Regulation No. 107 (M₂ and M₃ vehicles)

Proposal for amendments to Regulation No. 107 (M₂ and M₃ vehicles)

Submitted by the expert Germany^{*}

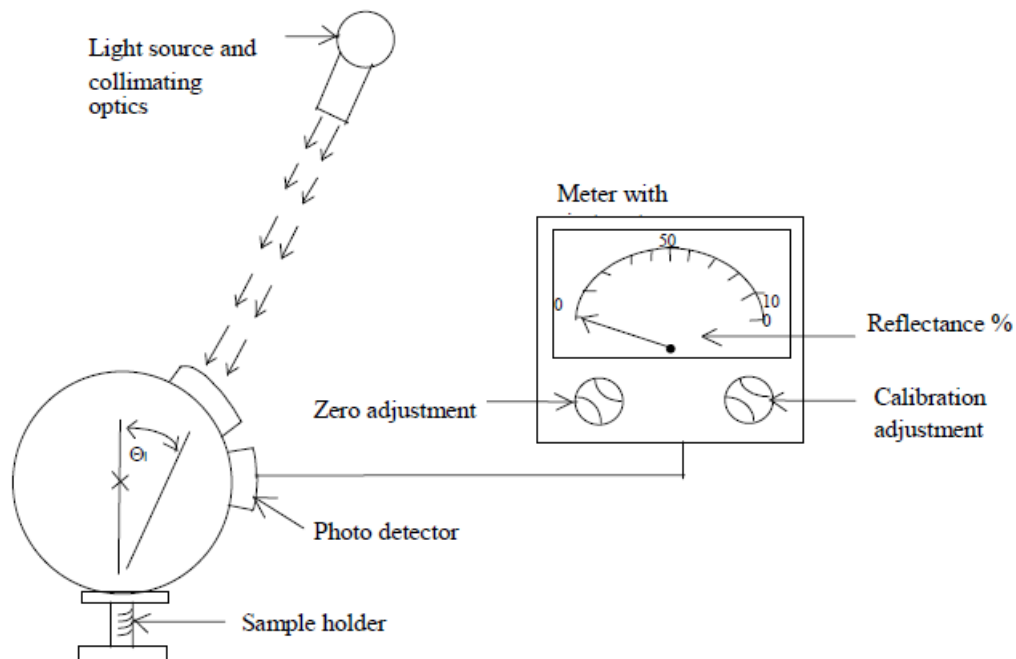
2. For determination of the reflectance values ρ_1 , ρ_2 and ρ_d an integrating sphere according to CIE 38:1977 shall be used.

The reflectance shall be either read directly from the indicating instrument or calculated according to the following formula:
